Director's Report

Project Name: 9101 Highland
 Description: Preliminary site plan approval recommendation & special land use approval
 Date on Agenda this packet pertains to: December 5, 2024

RE: 9101 Highland Road-Proposed Commercial Development- Preliminary Site Plan Review – 2nd Review

**Preliminary Site Plan / Special Land Use Review
for
White Lake Charter Township, Michigan**

DRAWING: C-5

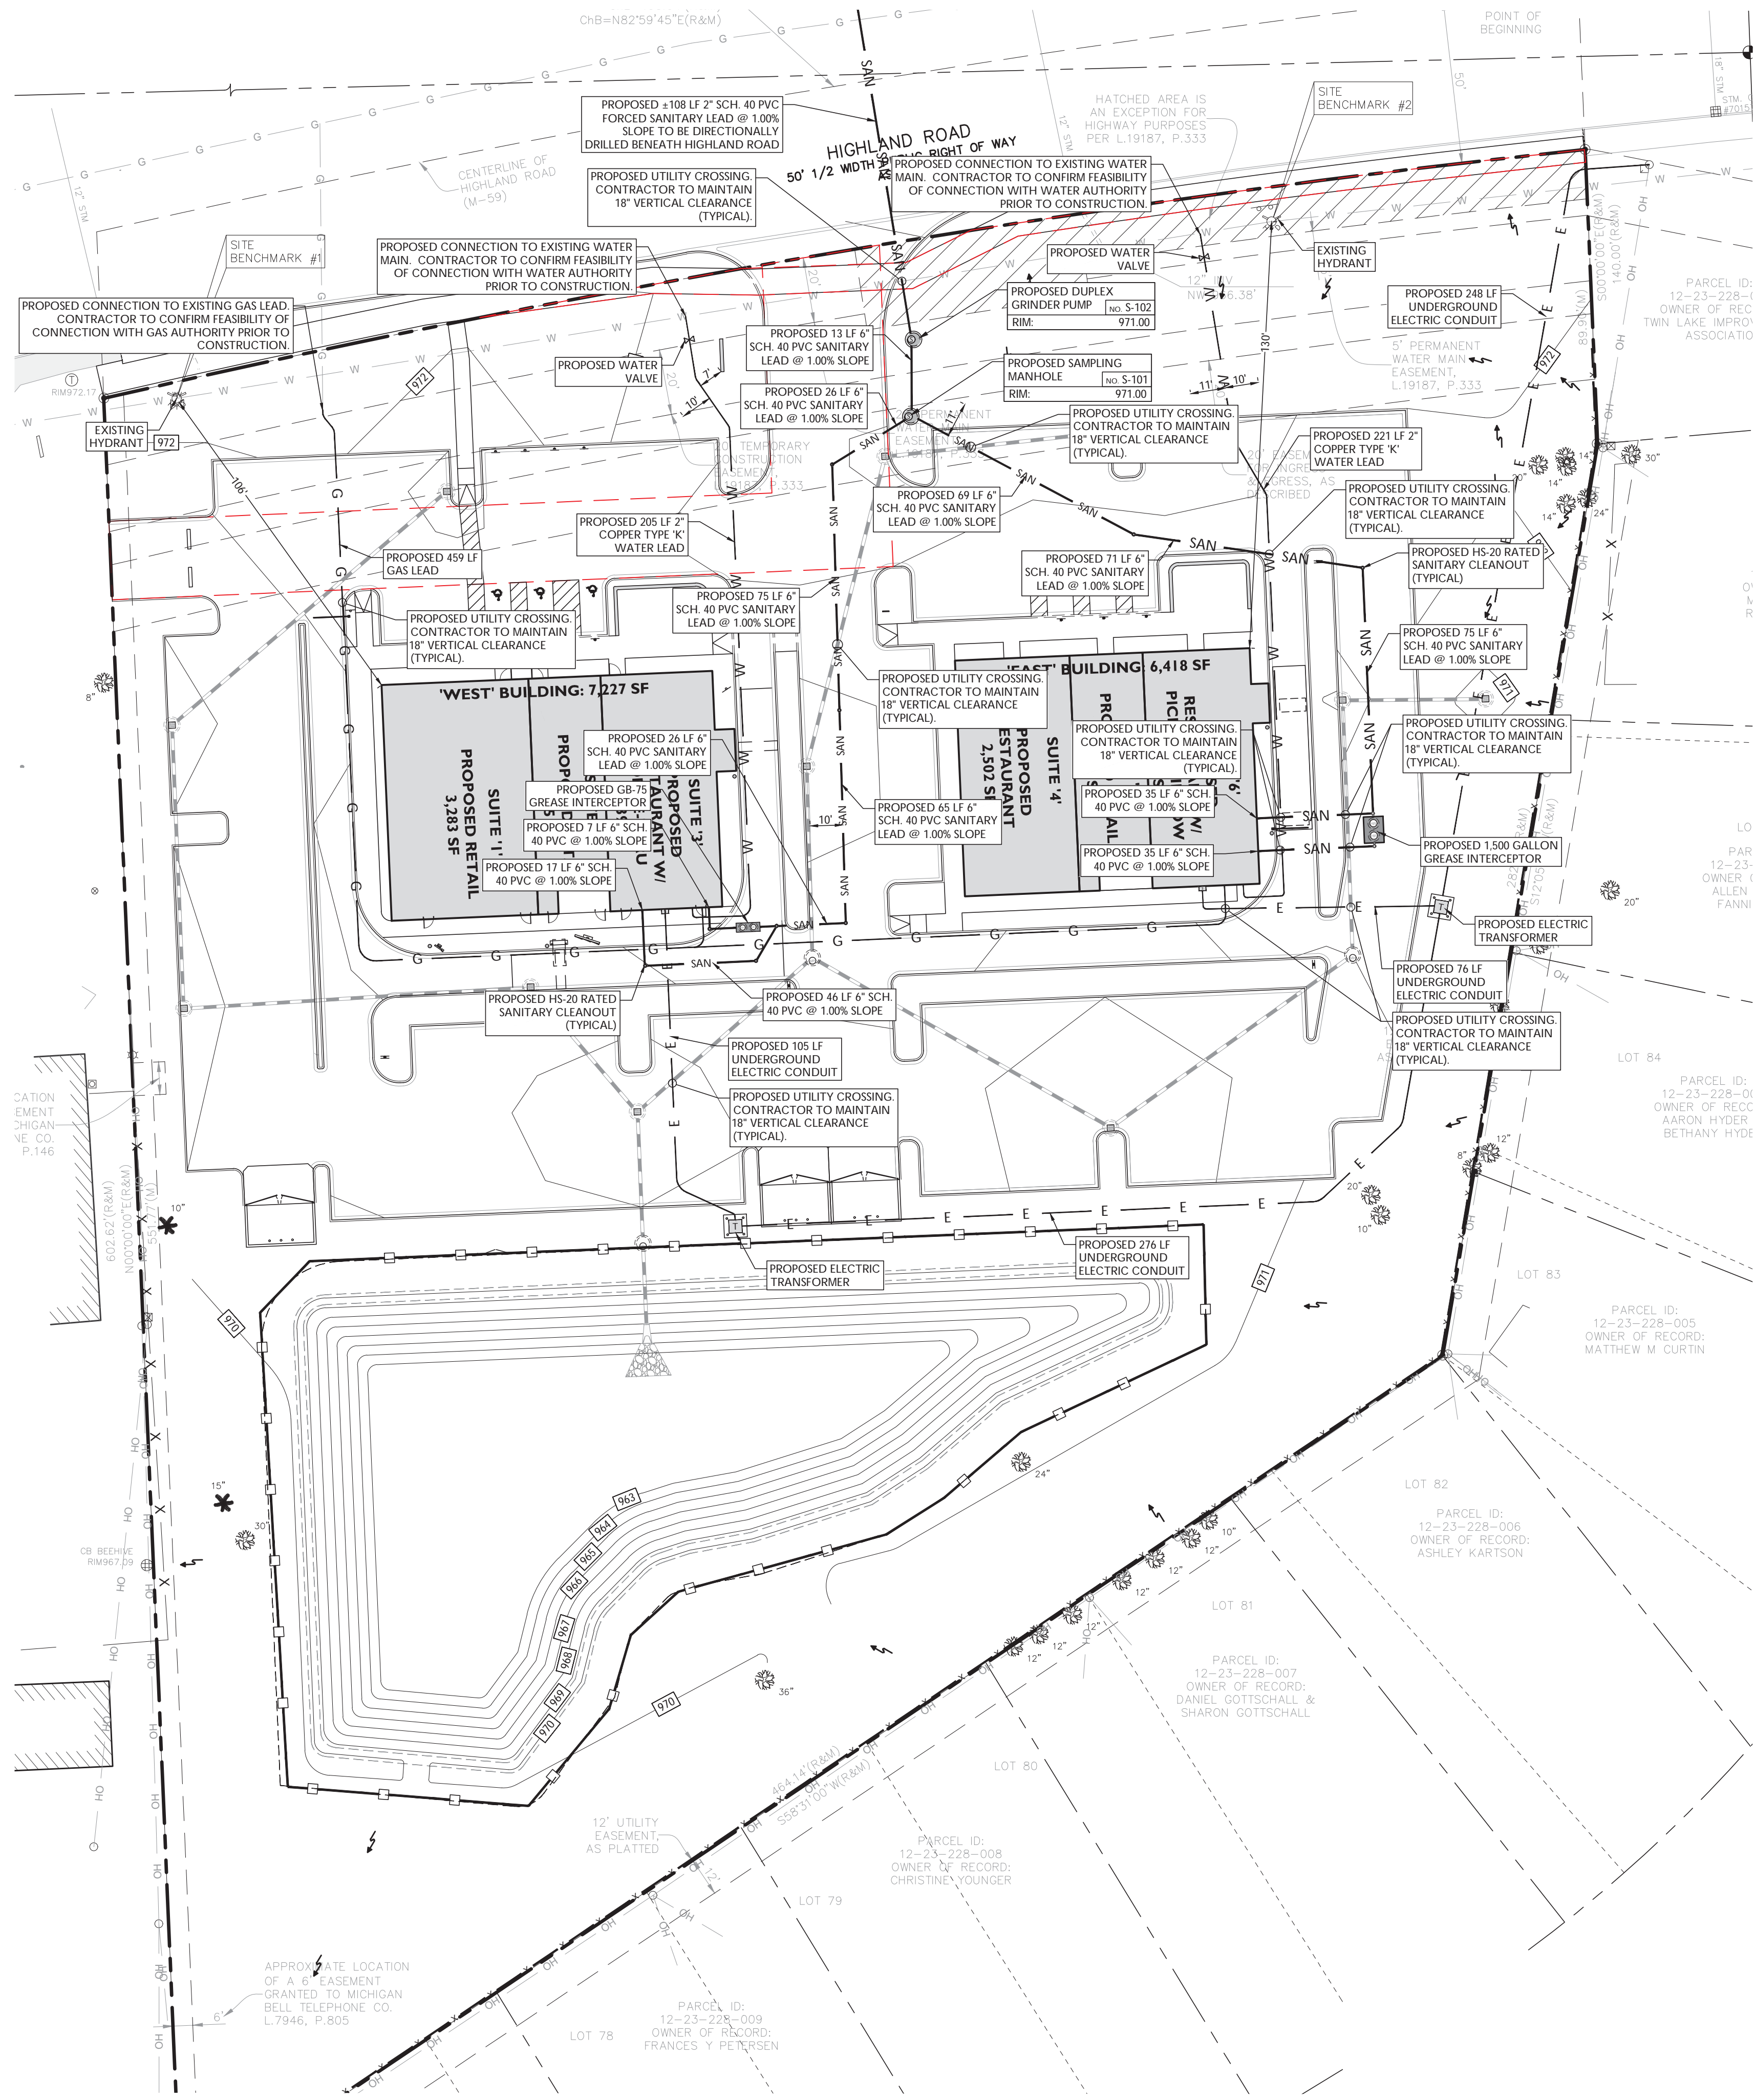
- n) *Sheet C-5- Remove duplicate proposed Water Quality Unit label (the label showing 15" diameter invert elevations).* **Comment addressed. Duplicate label has been removed.**

- o) *Sheet C-5-Retention basin slope scales to 1:4, which would require a fence around basin. Is the intent to fence in the basin?* **Comment partially addressed and remains. A fence is now shown around the basin. A 10' wide basin access gate is now shown as well as 10 LF of mountable curbing at the parking space across from the gate. The parking space across from the basin access gate shall be designated as an 'Authorized Vehicles Only' space and /or striped so as to allow maintenance vehicle parking and access to the retention basin.**

- p) *Sheet C-5- Provide/show retention basin spillway and pathway of overland flow. In addition, 1' of freeboard is required for the basin.* **Comment addressed at the PSP level and remains. A spillway and a general pathway of the overland flow are now shown. 1' of freeboard for basin is now shown. It will be required to be shown/demonstrated on the Final Engineering Plan that an overflow event from the retention basin shall not impact adjacent properties.**

- q) *Sheet C-5- Based on basin capacity and storage elevation for a 2-100 year back to back storm event, there would be surcharging in upstream piping with what appears to be storage of stormwater above some of the upstream storm sewer rim elevations. It will be required to be demonstrated on the Final Engineering Plan that the HGL will be contained within or at 1' below storm rim elevations.* **Comment addressed at the PSP level and remains. The basin has been reconfigured and the top of storage of basin has been lowered to match the proposed CB grate/rim elevations. We continue to note that the second half of our above comment regarding HGL will be required to be addressed on the FSP/FEP.**

- s) *Sheet C-5- Provide SCS Soil Types. In addition, provide water table information to substantiate that water levels shall return to preexisting conditions at least one time per year.* **Comment addressed at PSP level and remains. SCS soil types are now shown. Design engineer notes that a geotechnical report will be provided prior to FSP/FEP submittal to confirm the water table level.**
-

- t) *Sheet C-5-Demonstrate that the basin shall dewater a 100 year storm within 72 hours based on infiltration rates of soils present. **Comment addressed. Dewatering calculations have been provided showing that basin will dewater in 45 hours.***

- u) *Sheet C-5- Stormwater Management Calculations table- The incorrect property address is shown in this section. Please revise. **Comment addressed. Address has been corrected.***

DRAWING: C-7

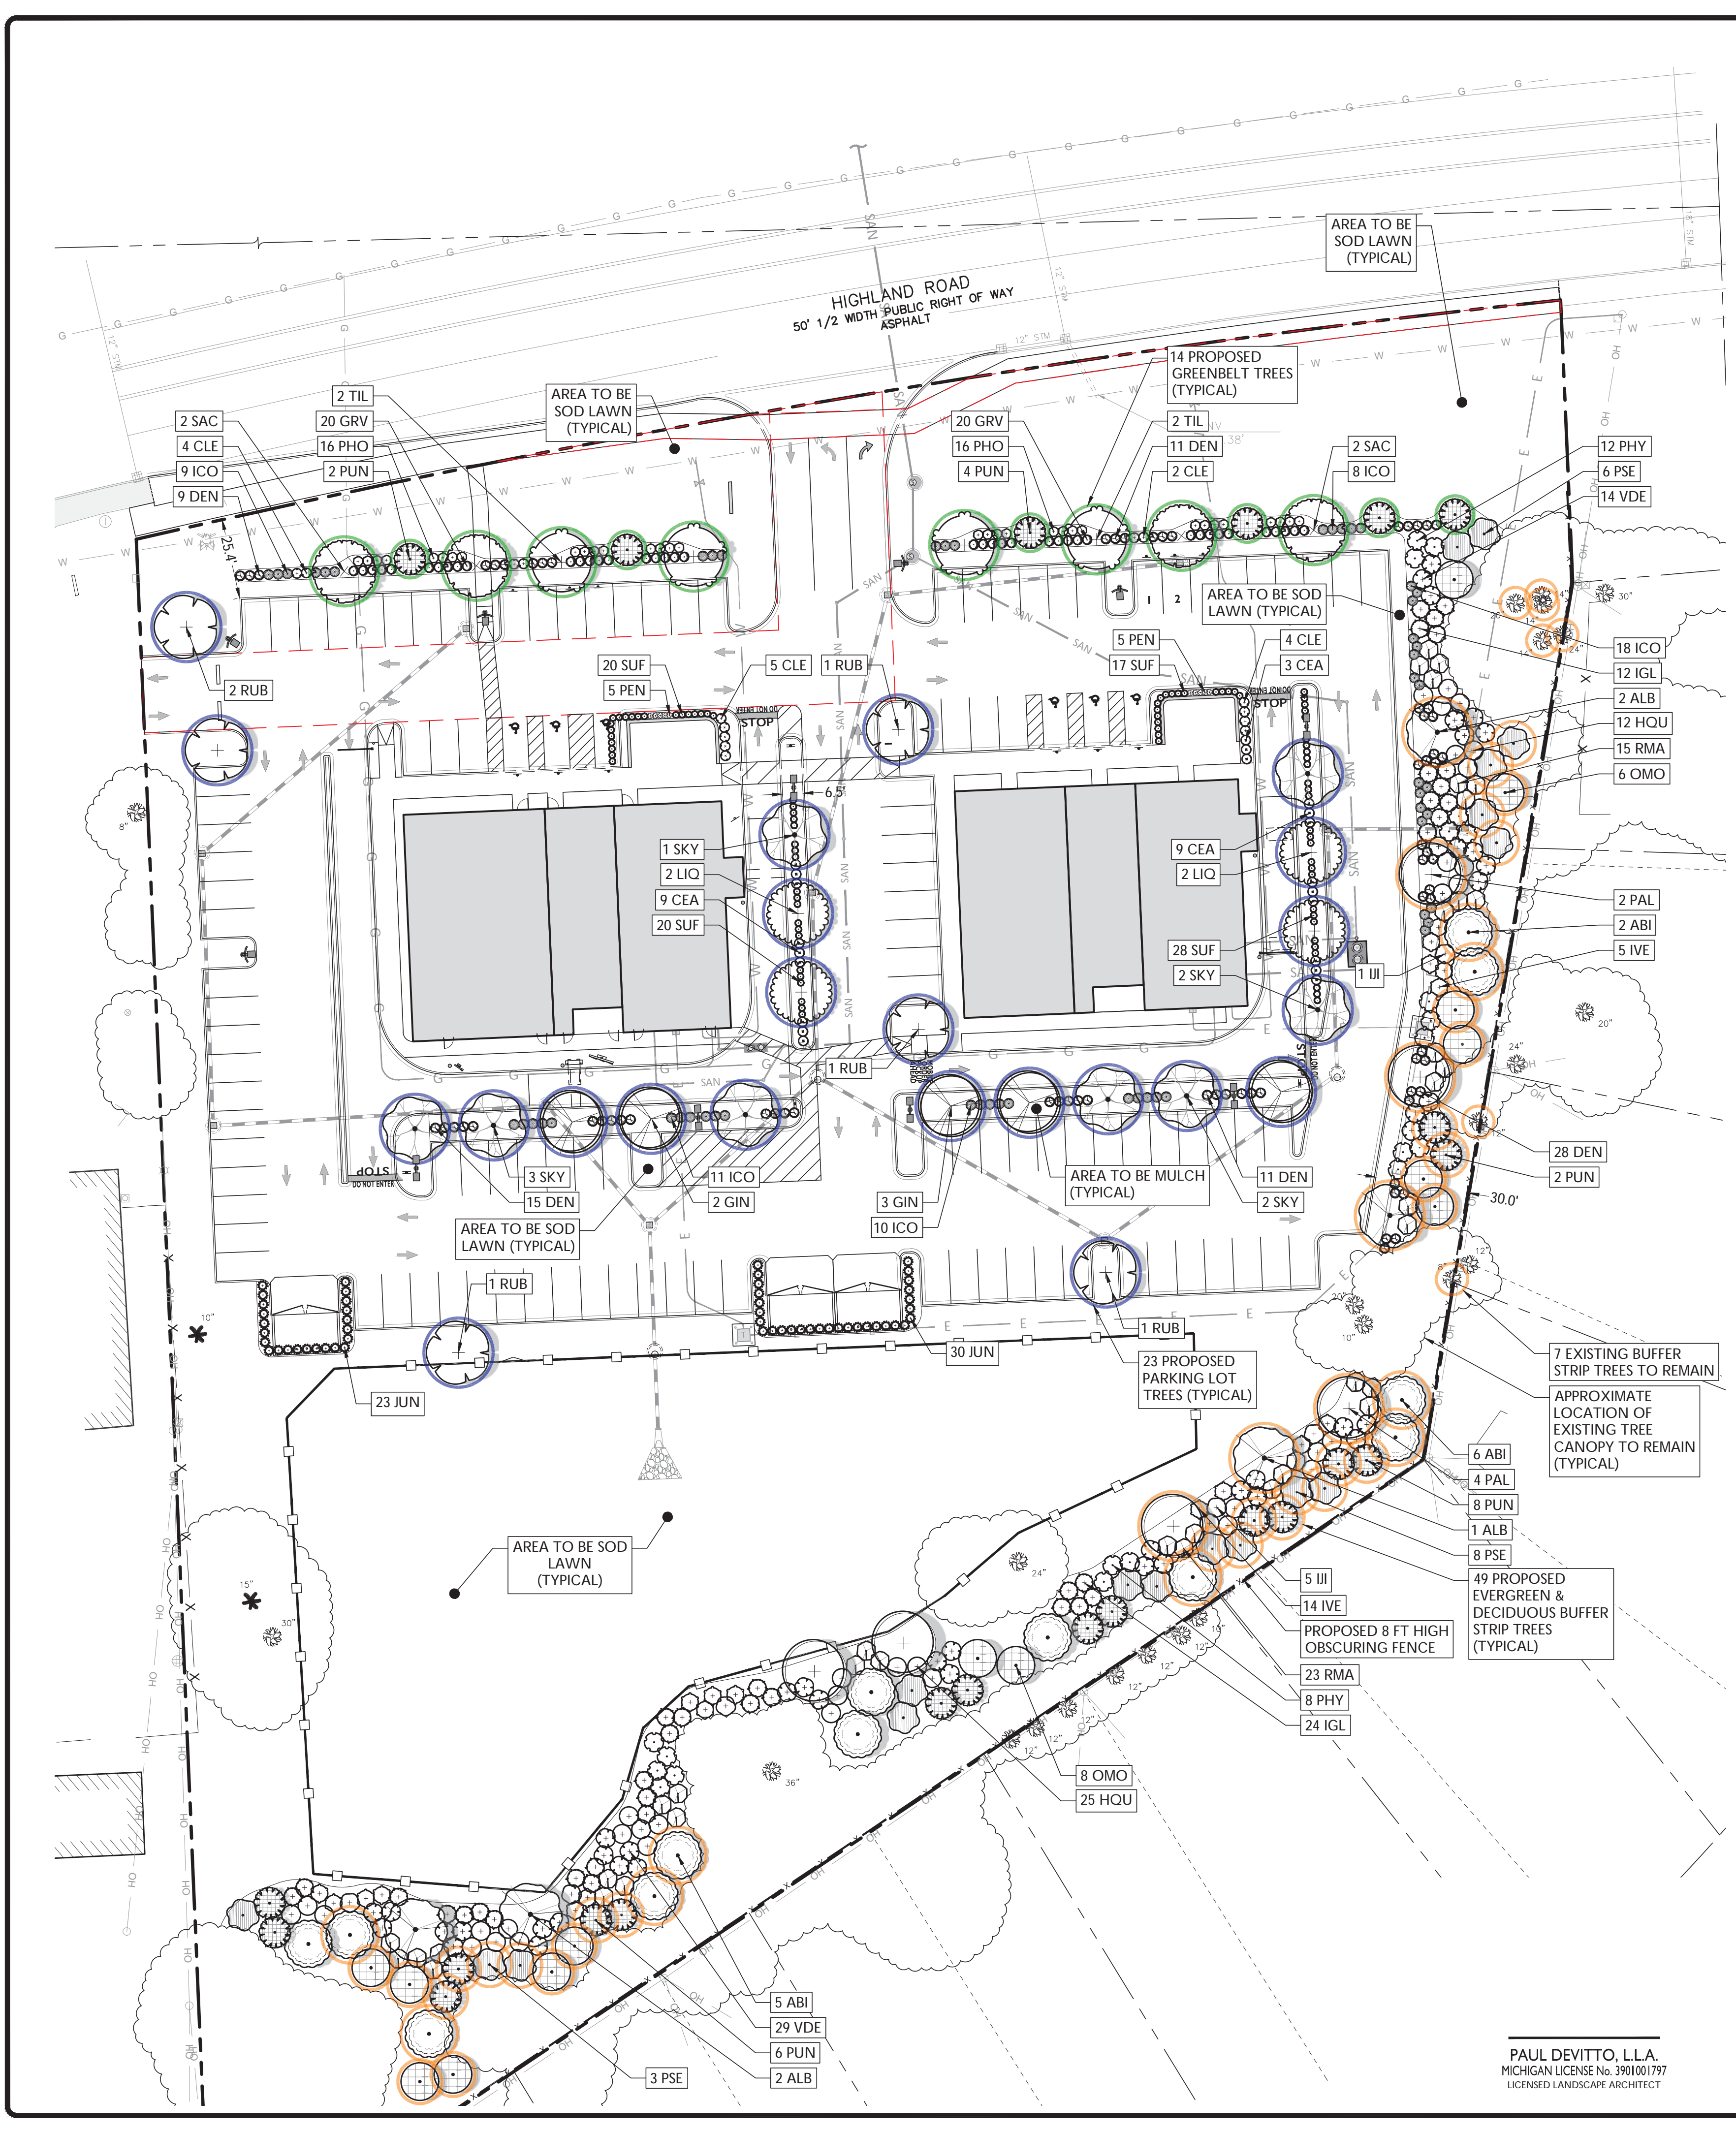
Given the site will have multiple tenants, Sheet C-7 should have a note stating that there shall be no flashing, oscillating, moving or intermittent type of lighting or illumination on the site.

CWA Comment: Information is still required to assess conformance to lighting standards however footcandle measurements shown on Sheet C-7 do not indicate light spillover into residential areas.
